Sundry Print Report

Well Name: KAIBAB TRAIL COM

Well Number: 90S

CONDITIONS OF APPROVAL

Planned P&A Wellbore Schematic

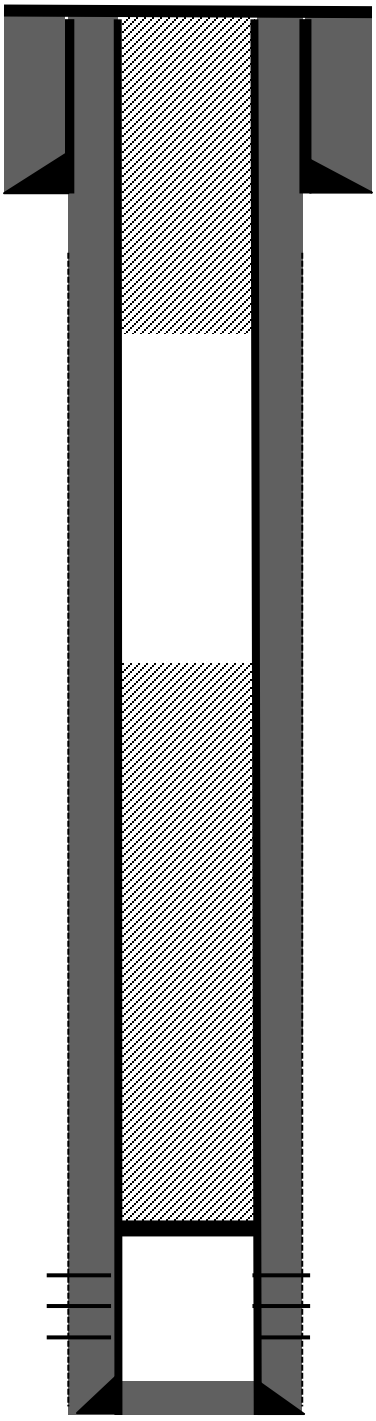
2. The following modifications to your plugging program are to be made:
   a. Adjust the top of Plug 1 to 890 ft to account for the BLM's Ojo Alamo top at 940 ft.

Limited raster logs available for the well. The induction raster log of the reference well and the proposed drilling in the area (White Crow drilling permits) supports that the Ojo Alamo Ss is located at 940 ft. Adjust the top of Plug 1 to 890 ft.
